**CARDINAL FREEMAN VILLAGE
137 Victoria Street, Ashfield**

**S75W APPLICATION TO MODIFY
CONCEPT PLAN APPROVAL MP 08_0245
AND
PROJECT APPROVAL MP08_0260**

RESPONSE TO SUBMISSIONS REPORT

**Prepared for
Stockland Property Services Pty Ltd**

Figure 1: The addition of solid and slatted elements to the design of the eastern façade of Building B4.

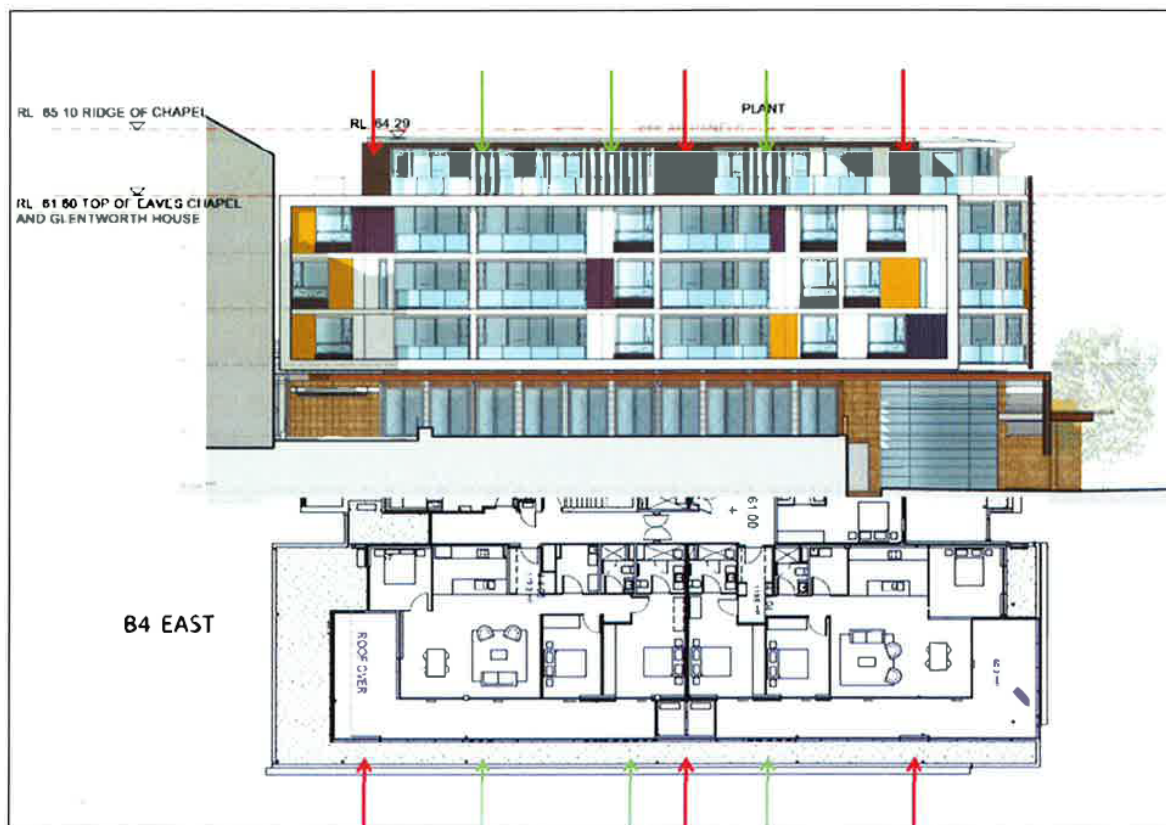
The Department notes that the design of the eastern façade of Building B4 has been altered and vertical solid and slatted architectural features/walls have been added to the top floor, east elevation. These features stand forward of the recessed glazed setback and are located directly beneath the leading edge of the roof line. A similar design approach was originally proposed for the previous MOD 1 application, but was subsequently deleted. The Department considers that the proposed treatment would add visual bulk at the upper floor and negates the positive effect of a setback at this level, which is necessary to ensure an appropriate relationship to the neighbouring Chapel building (refer to Figure 1):

Elevations to Building 4 have been revised to address the bulk issues raised by the Department and are contained in Appendix 2.
